CITY OF BOULDER
PLANNING BOARD AGENDA ITEM
MEETING DATE: October 6, 2016

Public hearing and actions on the following items related to development review applications for properties located at 4801, 4855, 4865 and 4885 Riverbend Road within the Riverbend Office Park:

Project Name: Boulder Community Health (BCH) Riverbend Medical Pavilion and Parking Garage

1 PUD ANALYSIS PLAN
1" = 30'-0"

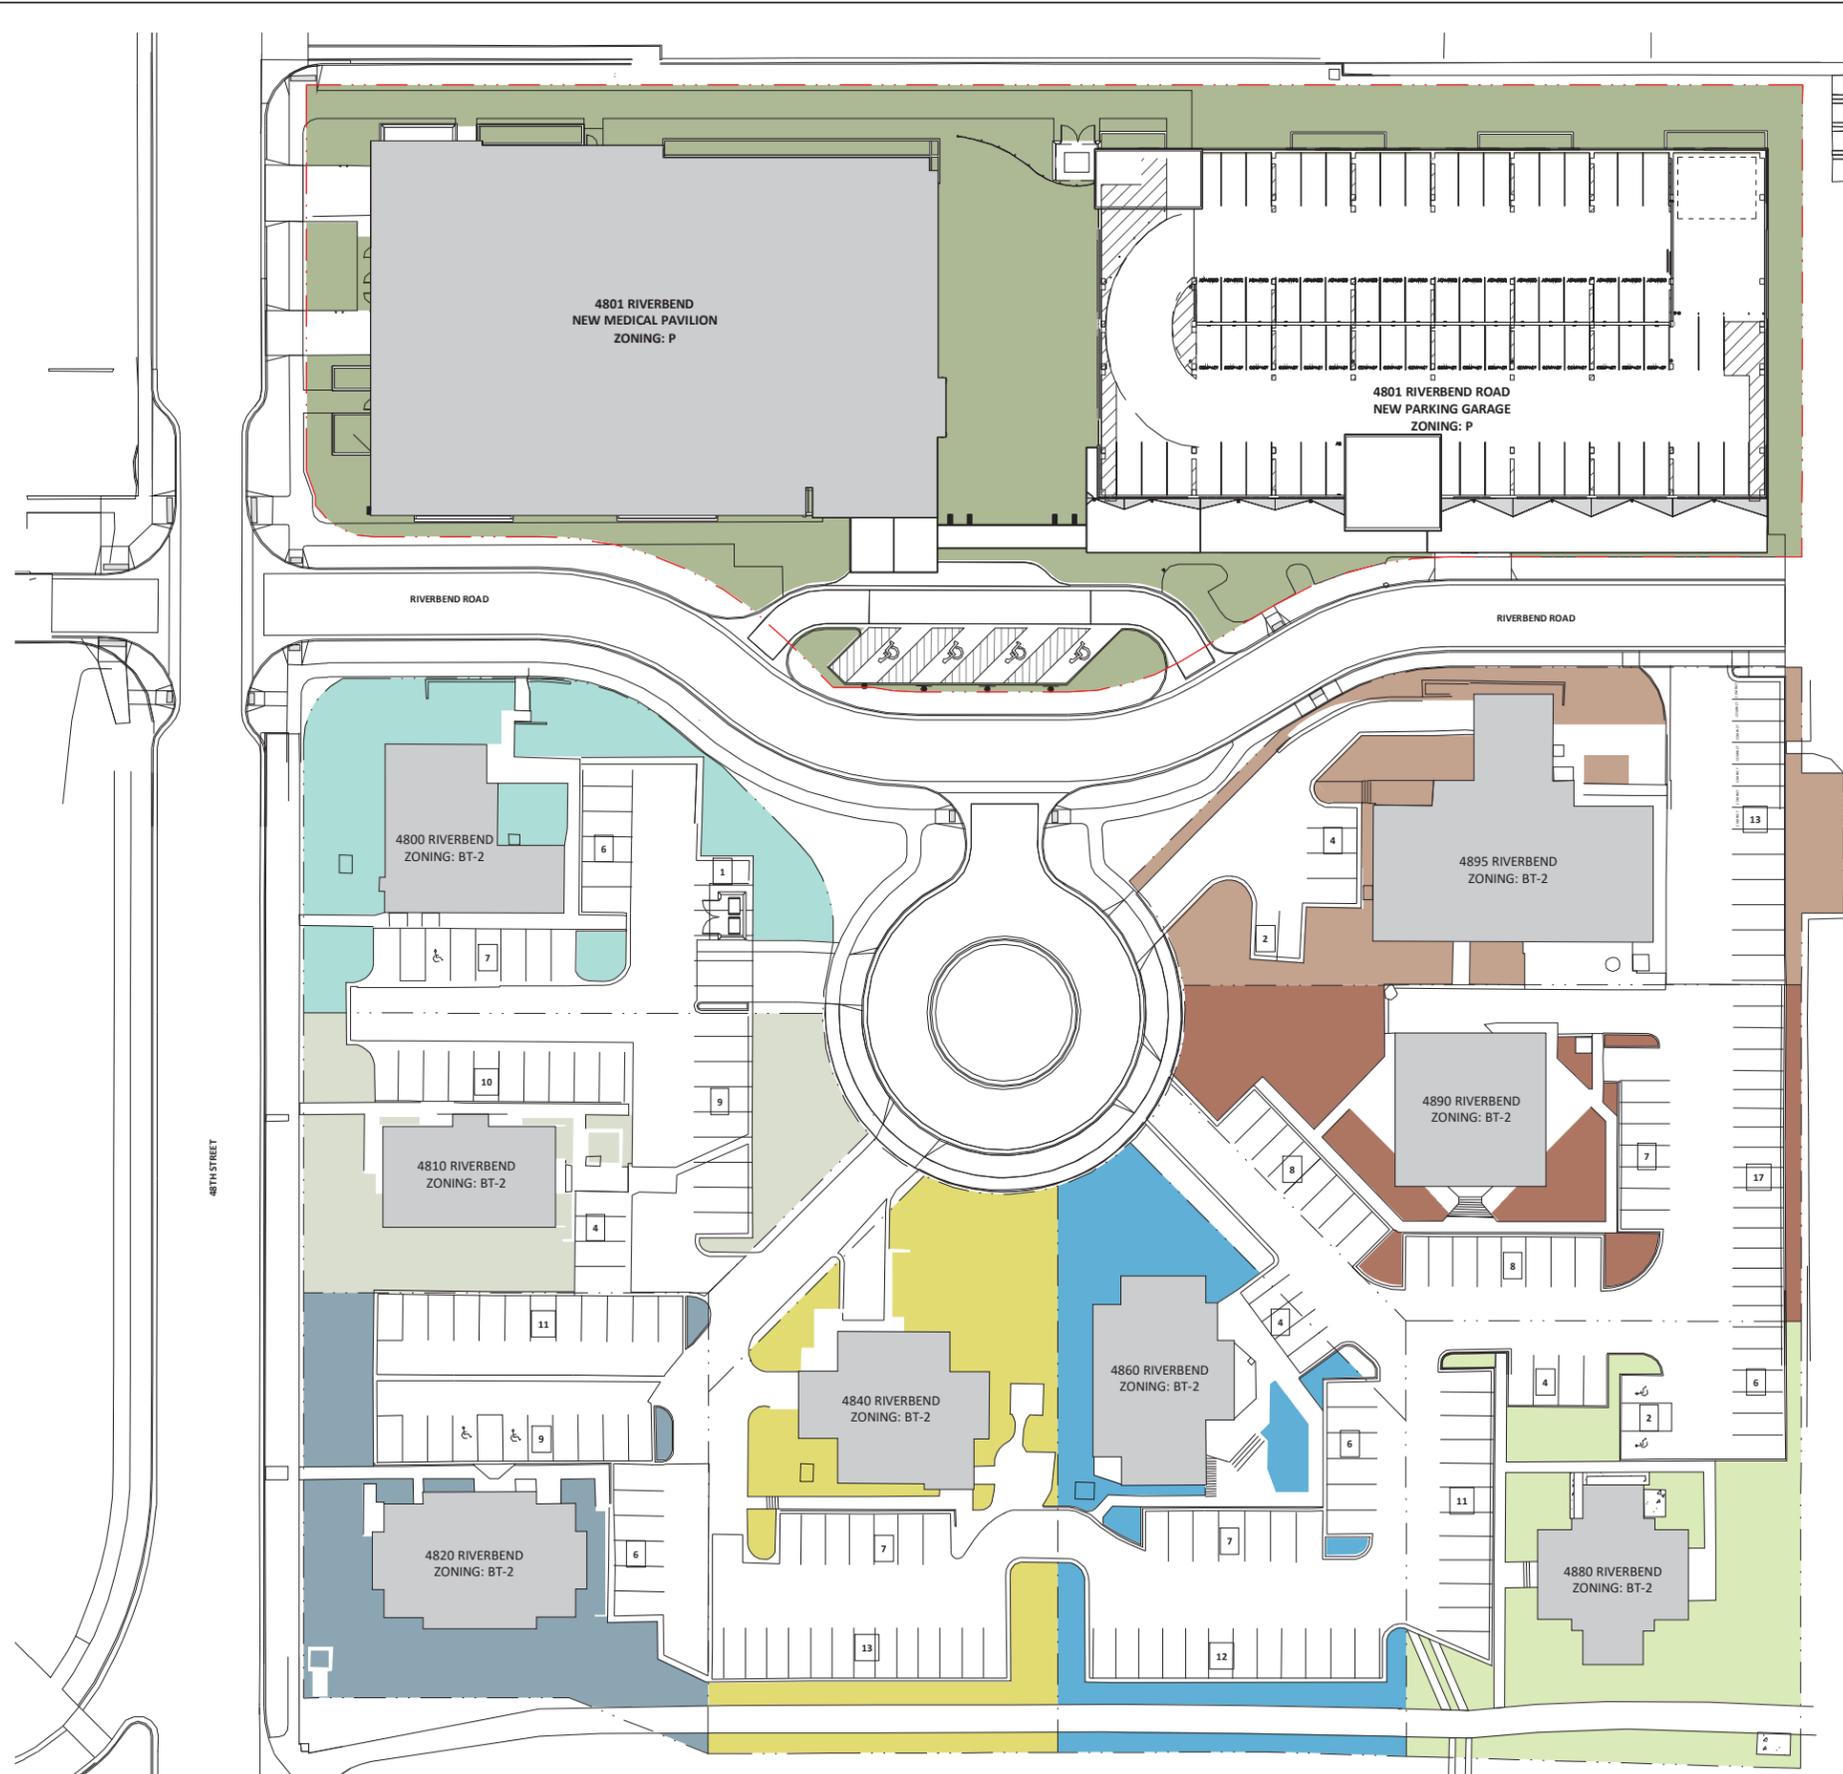
1. City requirements for parking are that any resulting number of a parking calculation be rounded down. Please revise Sheet SR1-1 for the 'existing (BT-2) Riverbend properties' to update the parking required column for 4800 through 4880 Riverbend to have one less parking space for each. Further, revise the totals in the general parking data on Sheet 01 to be 'Required Medical Parking: 234, Required Retail Parking: 16, and Total Required Parking: 250 spaces.'

3. It appears from the numbers on Sheet SR1-1 that construction work on the 4895 Riverbend property will result in the reduction of one parking space. This will require a 5% parking reduction for that property as the parking for the individual properties will continue to apply to the individual lots as previously approved for the Riverbend Office Park PUD. Please indicate that parking will not be shared between the properties on SR1-1 related to the previous PUD and submit responses for the parking reduction criteria of Section 9-214(h)(2)(K), B.R.C. 1981. Also, as stated in 'Plan Documents' below, the co-owner of that site will need to consent to the construction work and this parking reduction.

2. Correct the spelling of 'Generally' on Sheet SR1-1 in the 'Existing PUD Approval' section.
3. Please add a section on Sheet SR1-1 related to Uses and that allowed uses are according to the underlying BT-2 requirements and any existing non-conforming uses would be regulated according to Chapter 9-10, "Nonconformance Standards." Further, a statement shall be added that indicates that expansions and changes are subject to the city Site Review Amendment or Minor Modification processes as applicable. Also, see comments related to parking.

SR2-3

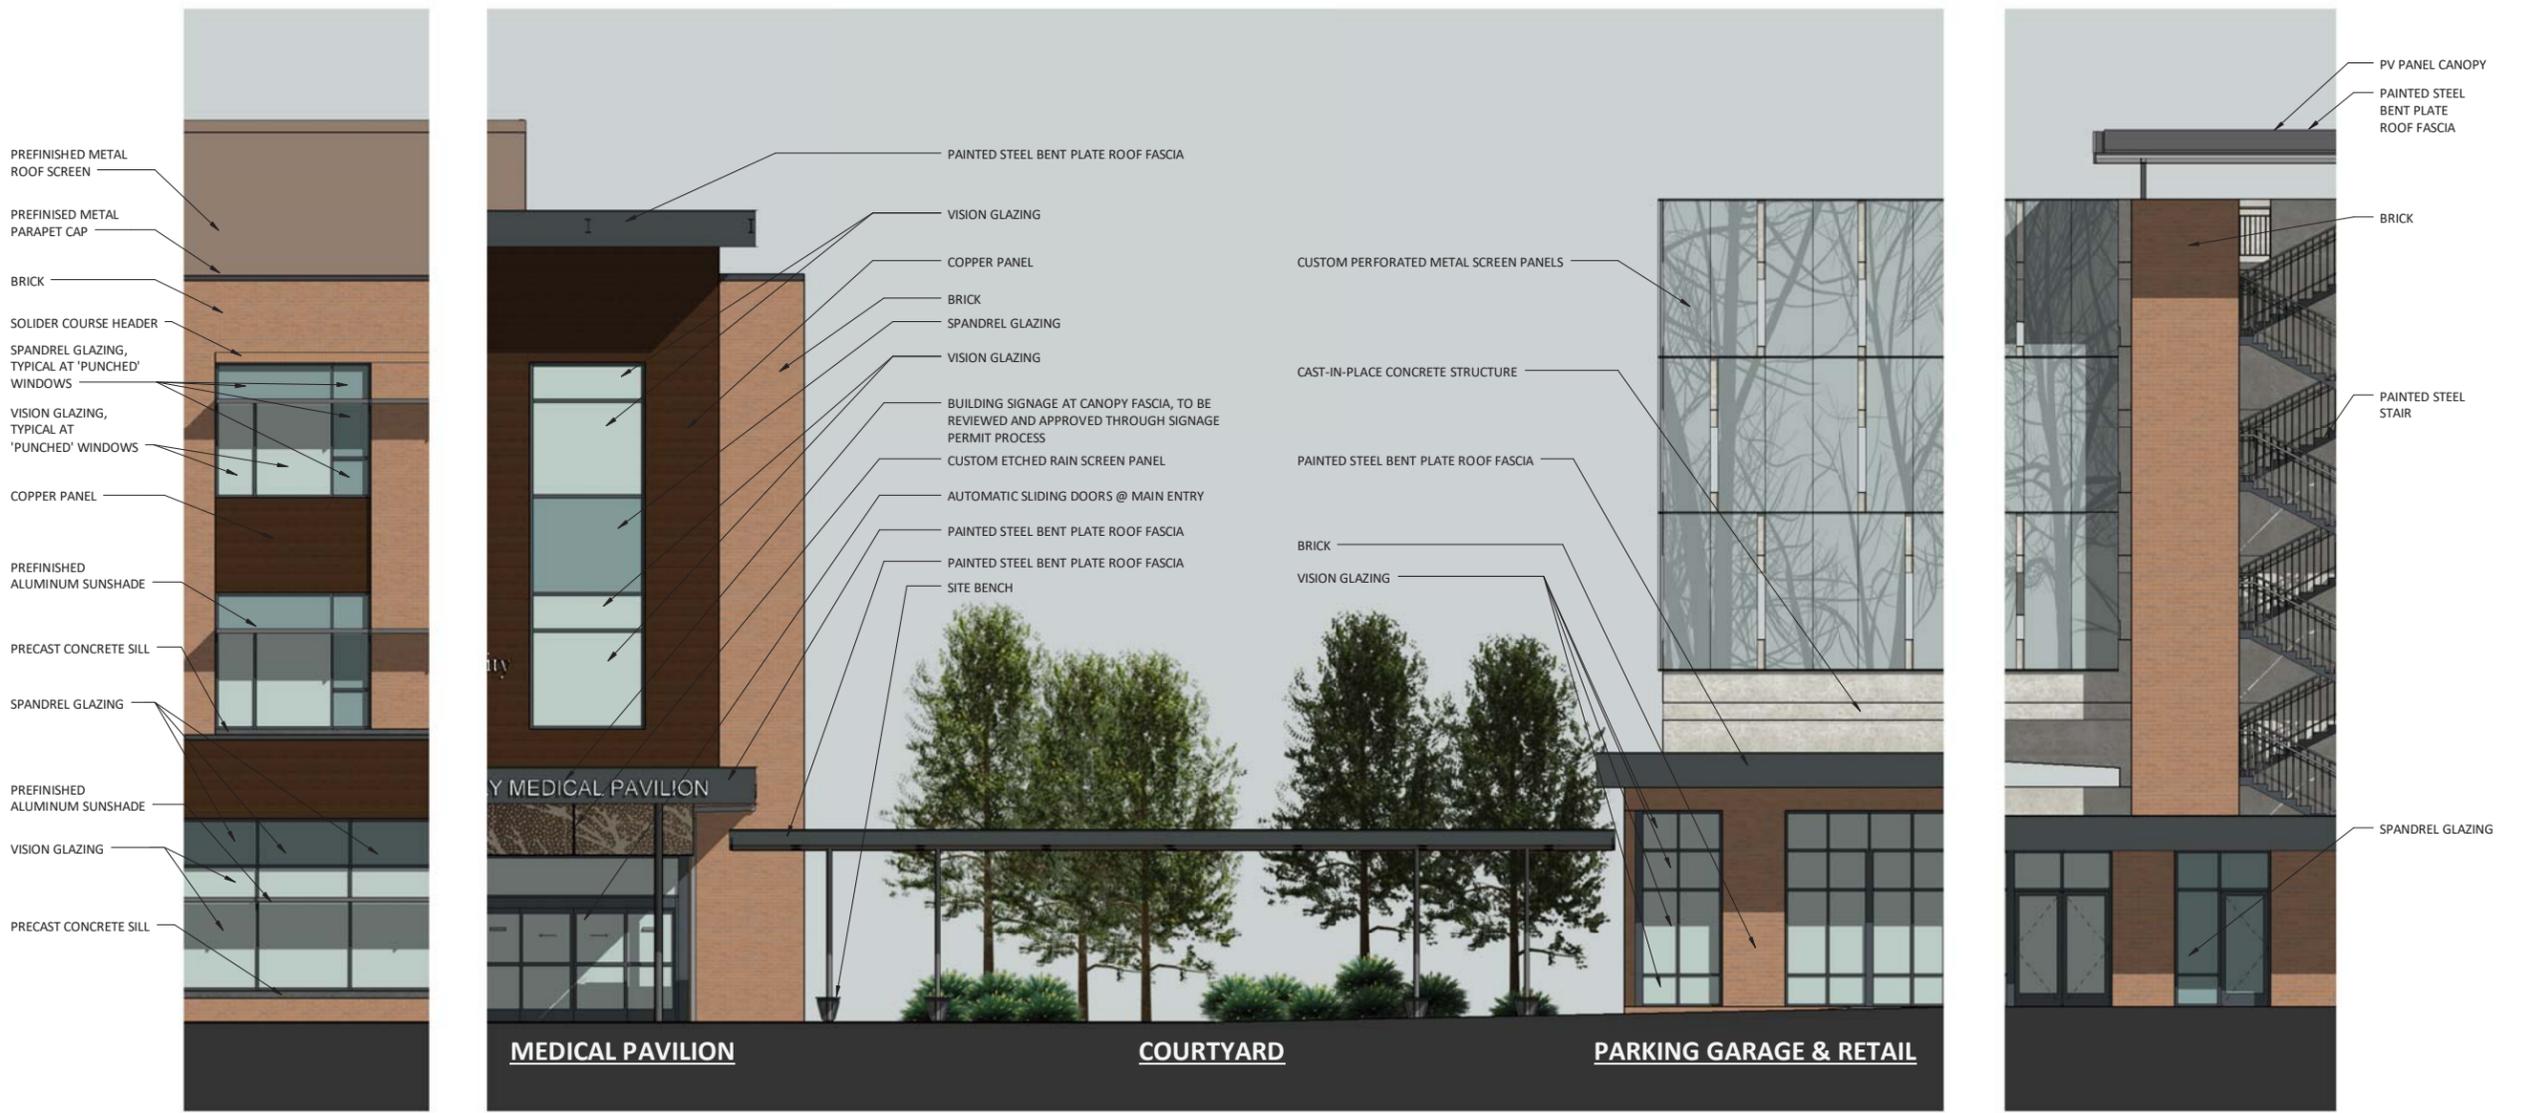
4. Revise the south elevation on Sheet SR2-1 to show the brick wall beyond as shown on SR2-3.
5. Construction work is proposed for the property at 4895 Riverbend in the area identified as Outlot 3 as well as Lot 8. Riverbend Sleep LLC has ½ ownership in Outlot 3 and owns Lot 8. Therefore, Riverbend Sleep LLC will need to consent to work by signing the application, by signing a letter of consent. In addition, Riverbend Sleep LLC will need to sign the Development Agreement.

SR3-1

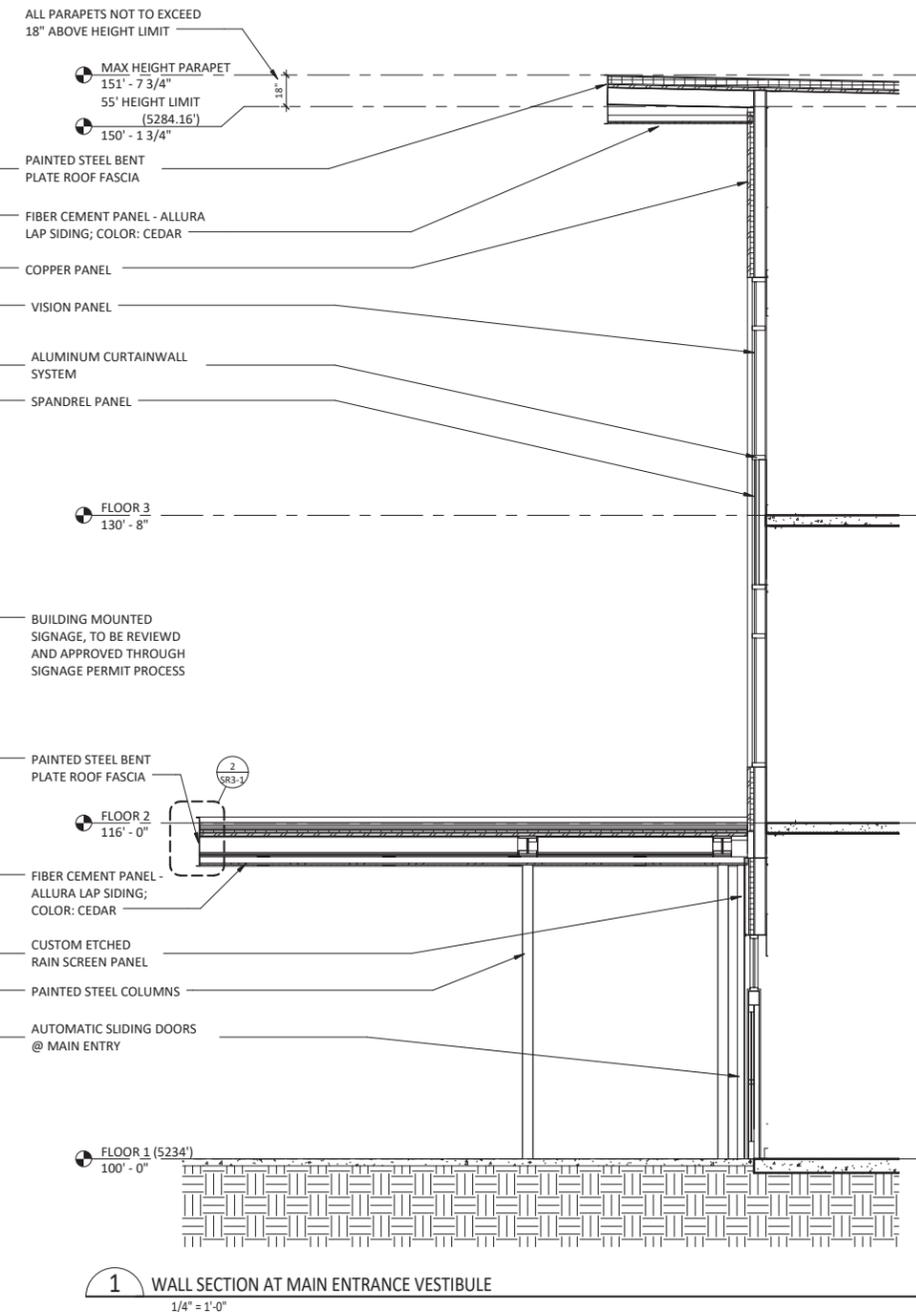
1. Staff finds the fiber cement panel proposed is appropriate. Please specify the exact type of fiber cement panel intended for the building on Sheet SR3-1.
2. Please clarify whether window panes will be light or dark colored. Some information in the sets conflict regarding the color.

ROOF APPURTENANCE DIAGRAM PARKING GARAGE

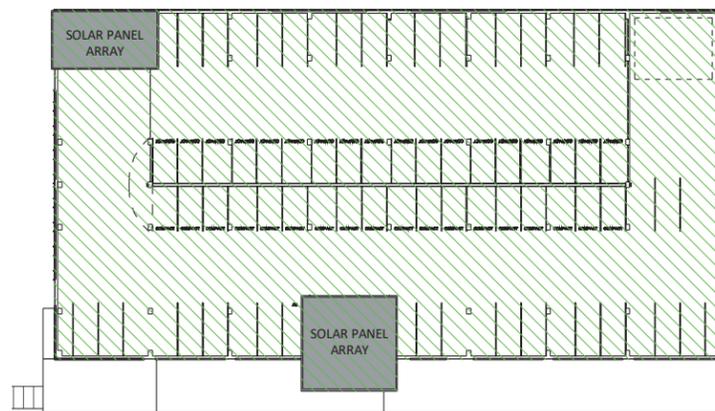
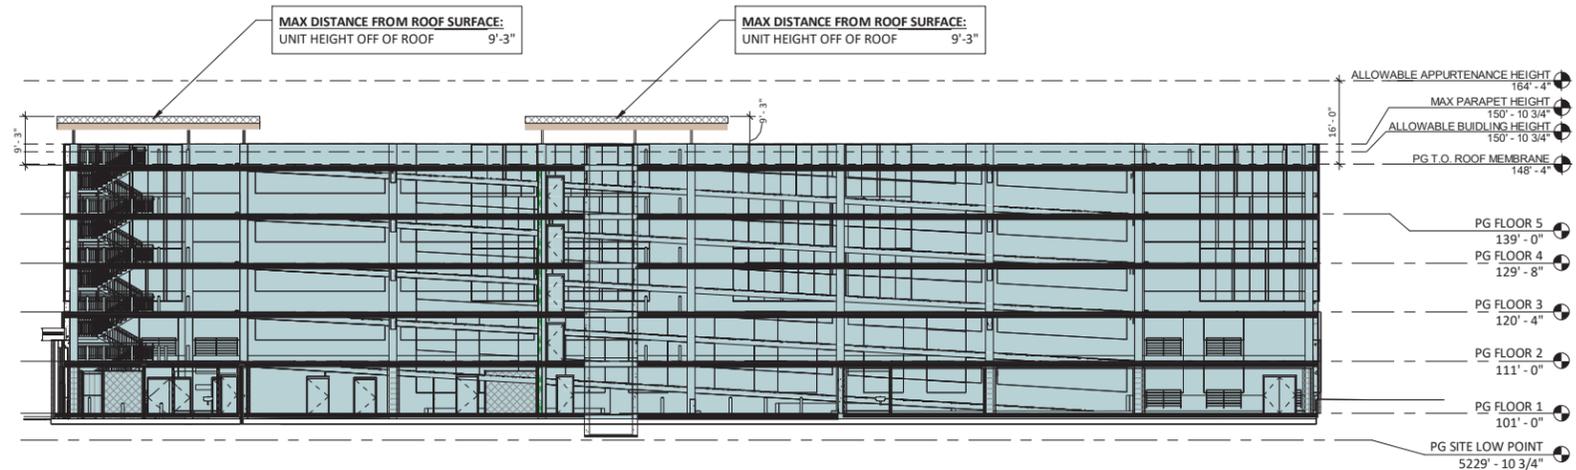
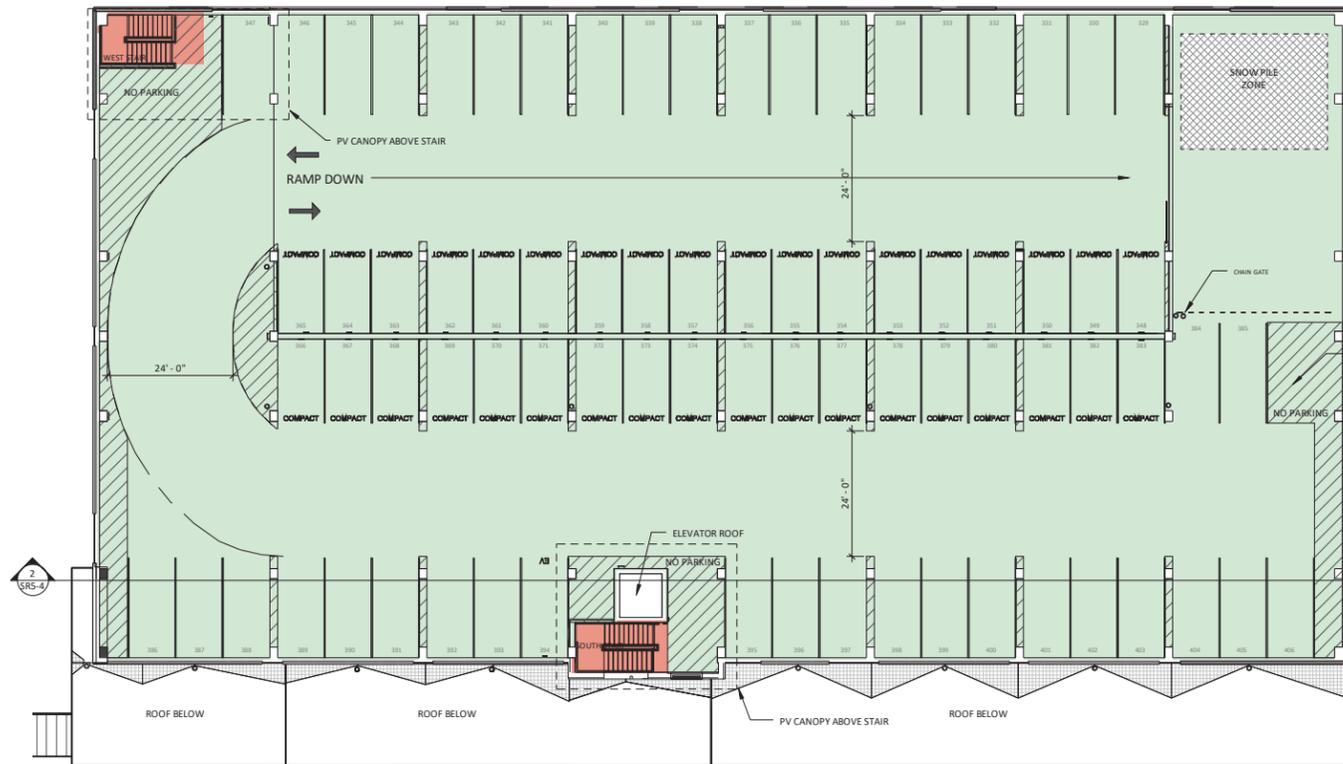
5. Provide roof plan of the parking garage that affirms that the solar arrays, which exceed the 55-foot height limit, do not exceed 25% of the roof area of the garage. These elements and the calculation may be added to Sheet SR5-4.
